DESIGN REVIEW RECOMMENDATION

FEBRUARY 5, 2014

810 DEXTER DPD PROJECT #3015507

Attachment "B" **Application for Design Review 810 Dexter Avenue N** DPD #3015507 January 22, 2014

SUMMARY OF EDG - ARCHITECTURAL CONCEPT EDG MASSING ALTERNATIVES

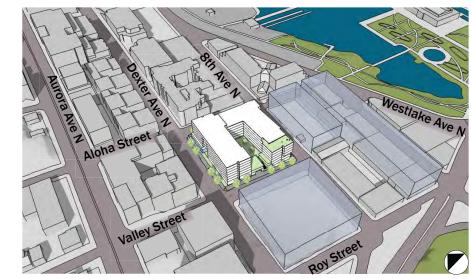
- 3. The Board noted that massing Option C appears to offer the best design response to the site, but the northeast corner in massing Option B appears to relate better to the corner. (A-10, B-1, C-2)

DEPARTURES

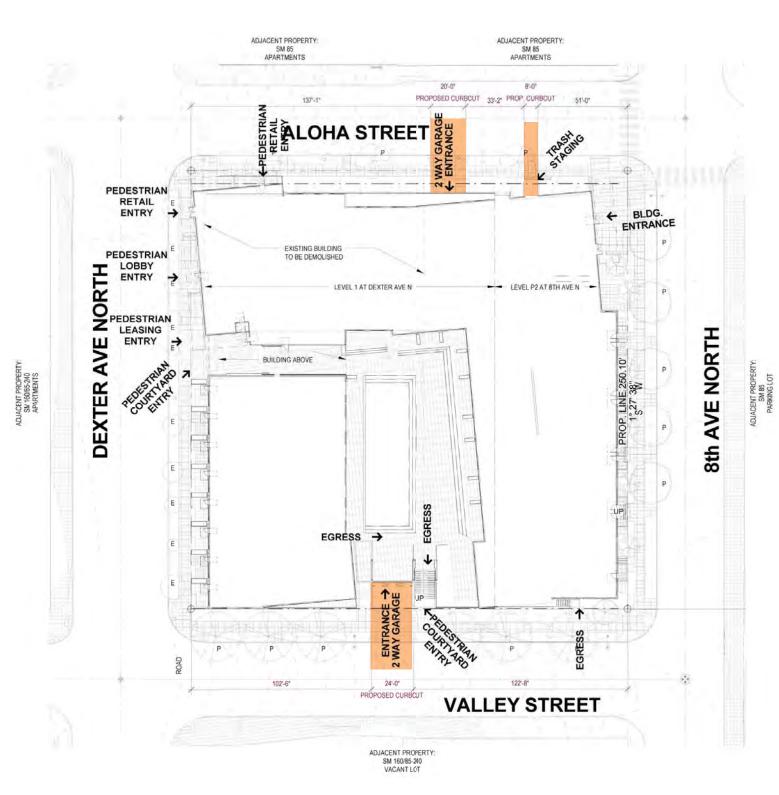
DEPARTURE REQUEST 4 - FACADE HEIGHT ELEVATION

DEPARTURE REQUEST 2 - PERMITTED SETBACK LEVEL

DEPARTURE REQUEST				
#	DEVELOPMENT STANDARD REQUIREMENT	REQUEST/PROPOSAL	JUSTIFICATION	
1	STREET LEVEL DEVELOPMENT STANDARDS (RETAIL SETBACK) SMC 23.48.014.E3 Required street-level uses shall be located within 10 feet of the street lot line, except if required amenity area or other required open space separates the façade from the street.	The proposed retail frontage is angled with a setback of 18'-2" – 20'8"	•This site has a unique proximity to the South Lake Union Park; pedestrians on Aloha St. or 8th Ave N have direct access to the park which is just one block to the east. •The proposed design includes a retail use and primary building entry/lobby at this corner. The design includes a pedestrian plaza associated with these spaces orientated to the street. Although the plaza is not being counted toward required amenity area, and open space is not required by code, the policy behind the open space exception to the setback limit applies equally to this circumstance.
